SUBJECT: PUBLICATION OF FINAL STAFF TECHNICAL POSITION (STP) ON
"INVESTIGATIONS TO IDENTIFY FAULT DISPLACEMENT HAZARDS
AND SEISMIC HAZARDS AT A GEOLOGIC REPOSITORY"

NUREG-1451

STAFF TECHNICAL POSITION ON
INVESTIGATIONS TO IDENTIFY FAULT DISPLACEMENT HAZARDS
AND SEISMIC HAZARDS AT A GEOLOGIC REPOSITORY

FIGURE 1 — Example of an Acceptable Approach to the Identification of Fault Displacement Hazards and Seismic Hazards. Numbers next to the process blocks correspond to the technical position statements described in the text. See Figure 3 for an expansion of process block 3.1.3.

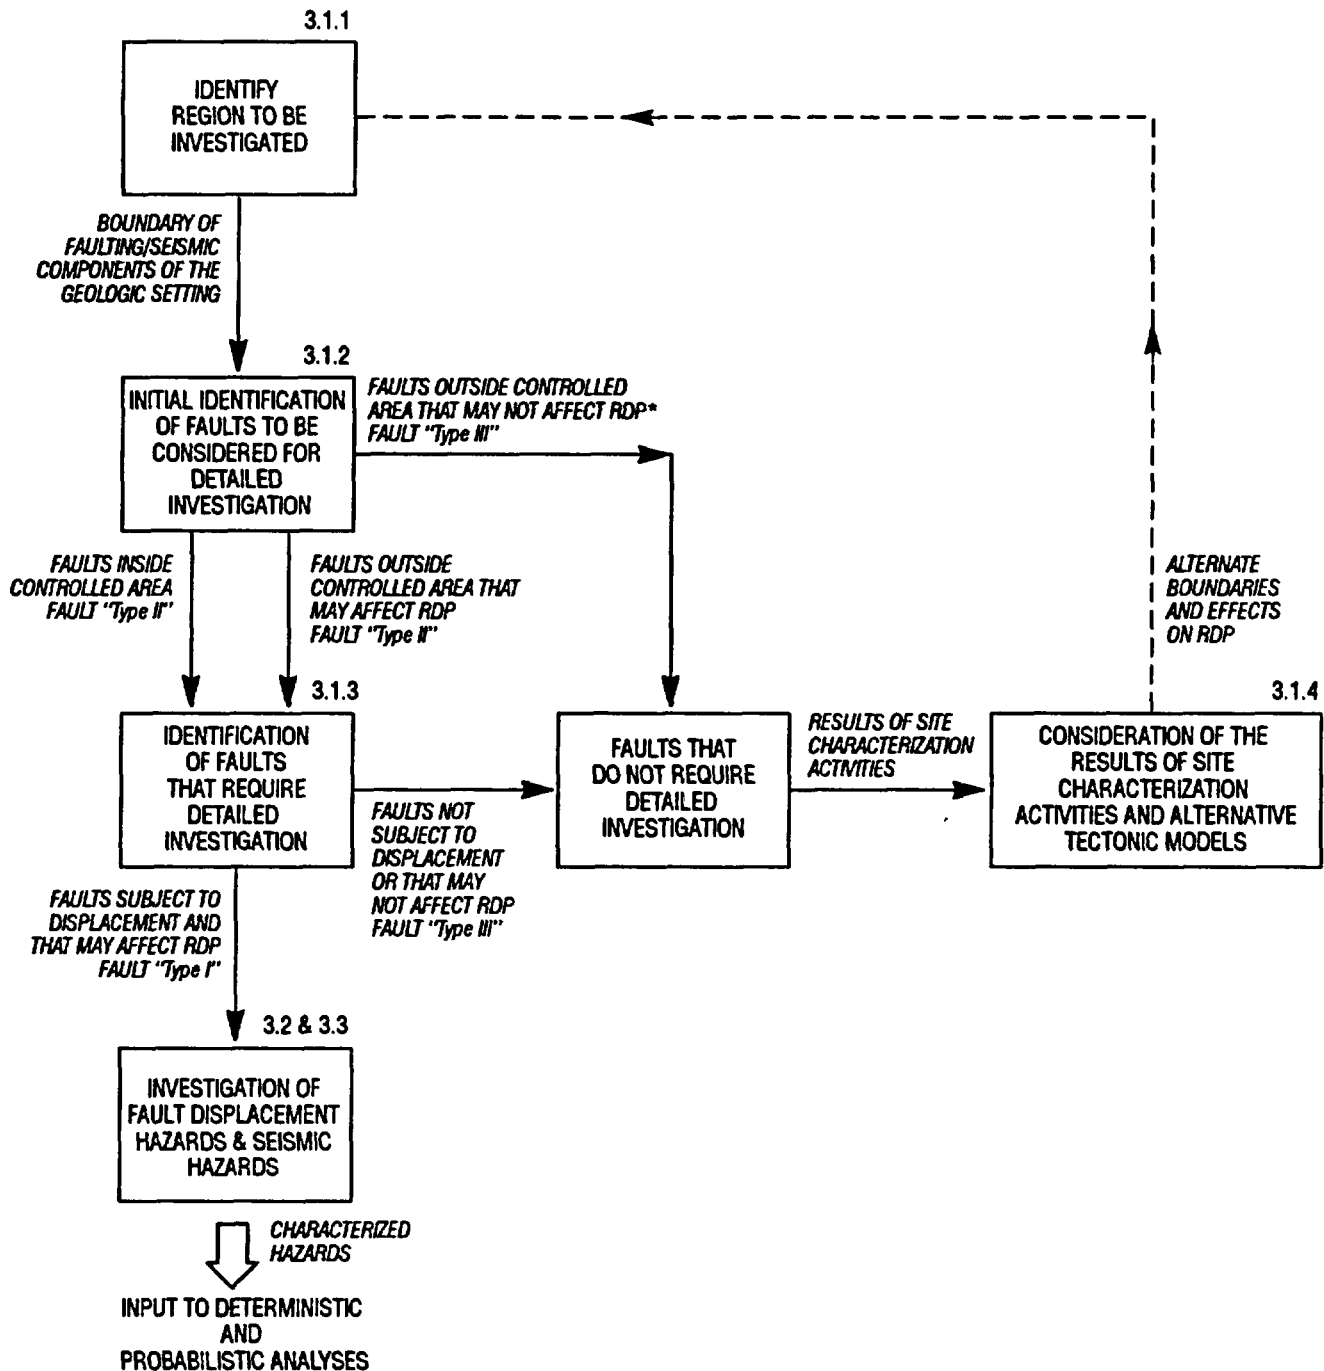
The STP should not preclude the use of probabilistic assessments of candidate faults lying outside the controlled area. A clarifying statement that a qualitative probabilistic performance assessment is acceptable should be added to the text accompanying Figure 1.

Figure 2 — Hierarchy of Elements in the Geologic Setting.

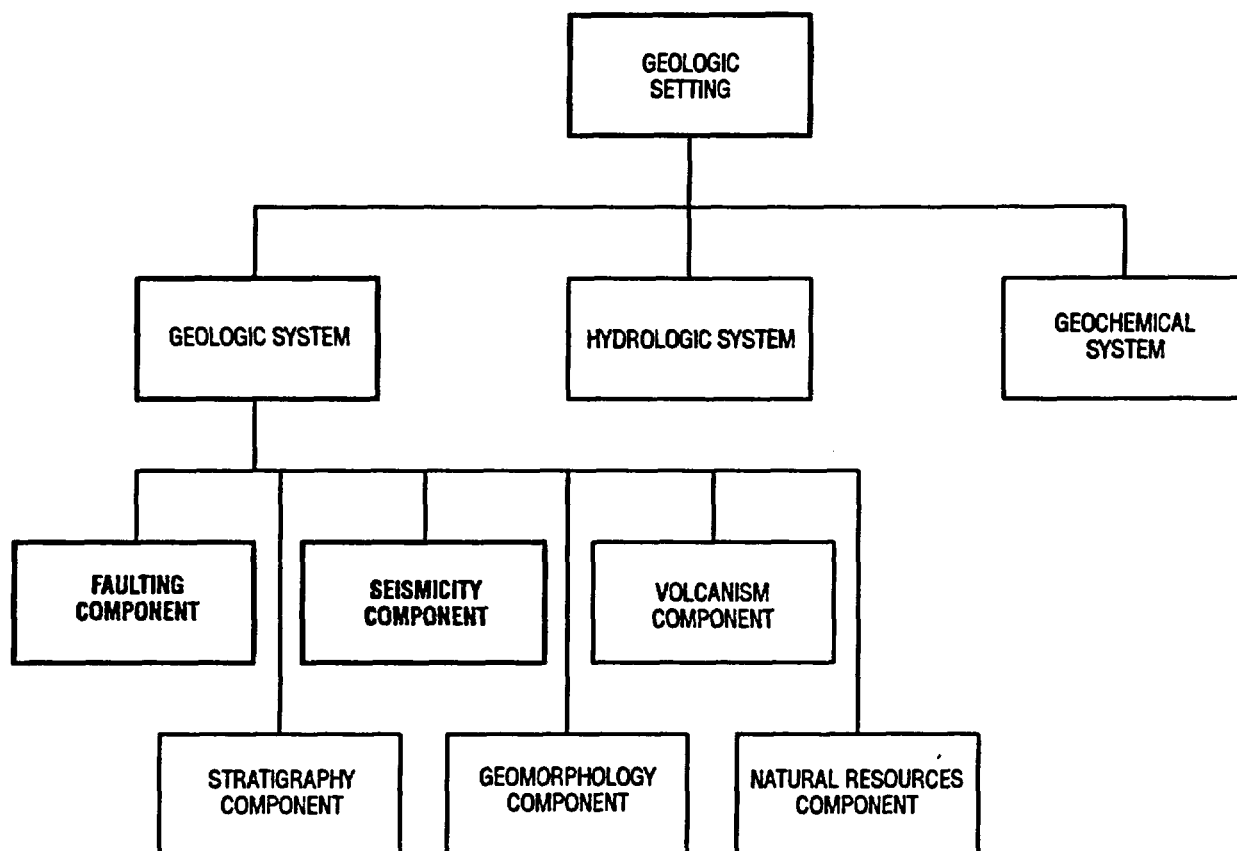
The definitions given on Figure 2, page 26 that the "region is within the geologic setting [sic] and on page 6, item (2) where "components of the geologic system (are) acting within the geologic setting" appear to be in conflict with each other and the definition for geologic setting given here. The conflict might be resolved if the glossary was expanded to include the definition(s) for the various "systems," "settings," and "components." In addition, although the "geologic setting" definition is cast in the concrete language of 10 CFR Part 60, this glossary offers an ideal opportunity to remedy shortcomings of the 10 CFR Part 60 language by expanding on that definition, particularly as it relates to the southern Basin and Range region that includes Yucca Mountain.

The staff considers that the term "region" can have varying definitions, depending on the application. With respect to Figure 2, the term refers to the area which encompasses the boundaries of the "geologic," "hydrologic," and "geochemical" system settings; with respect to the definition of "geologic system setting," the staff considers the "geologic setting" to be that area encompassing all of the geologic component settings.

The term "geologic setting" is already defined in 10 CFR 60.2, in the context of its constituent parts (e.g., the "geologic," "hydrologic," and "geochemical" systems). In the context of the investigations described in this STP, the staff has attempted to provide additional definitions of how the constituent parts, themselves, may be viewed. However, in response to this comment, the staff has revised the text in Subsection 3.1.1 and Figure 2 to further clarify the staff's intent in this area.

Figure 3 — Staff Technical Position 3.1.3: Detail to the "Approach to the Identification of Faults that Require Detailed Investigation (i.e., "Type I" Faults). Refer to the text for the discussion of this two-step process. Also see Figure 1.

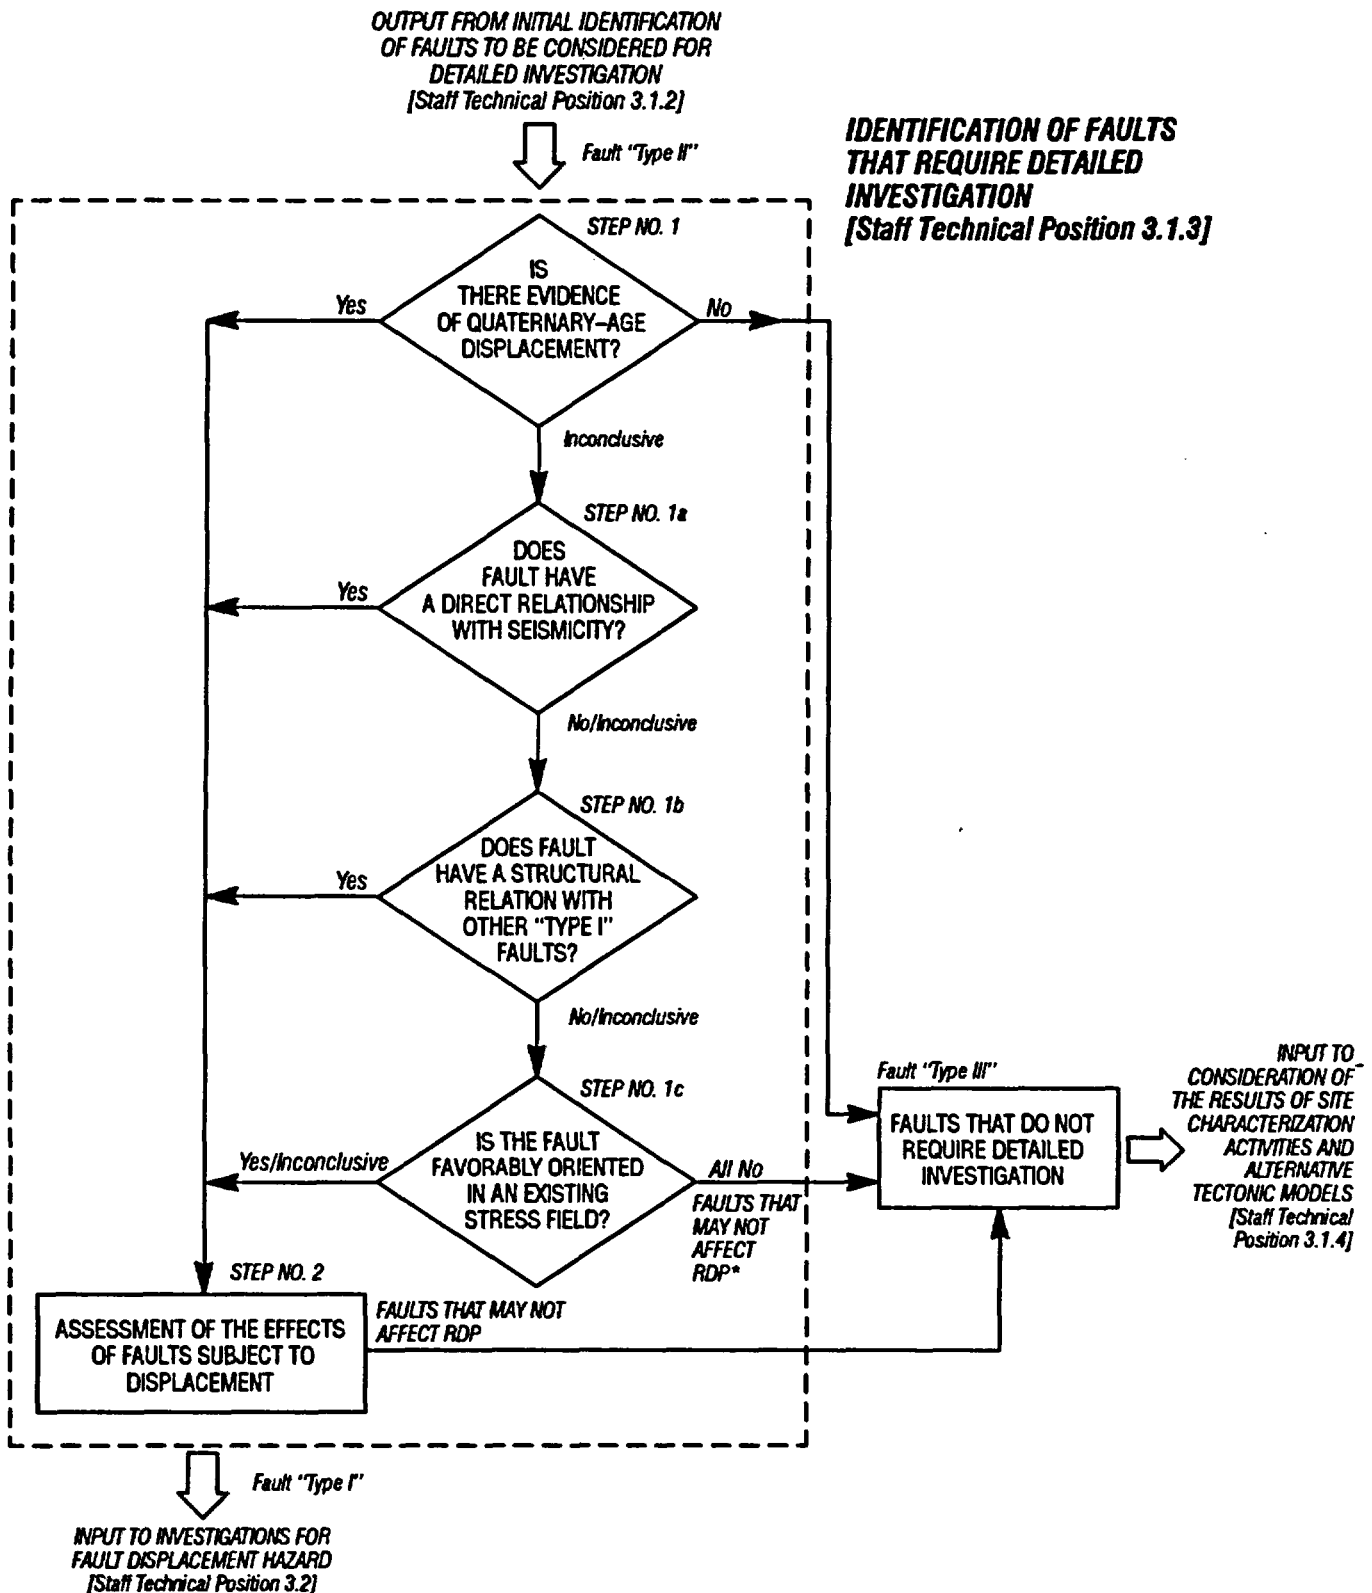
The staff should revise Figure 3 of the STP to indicate that only if Quaternary-age evidence is incomplete or unclear, should secondary criteria be evoked.

The staff agrees with this comment and has revised both the text and Figure 3, as suggested.
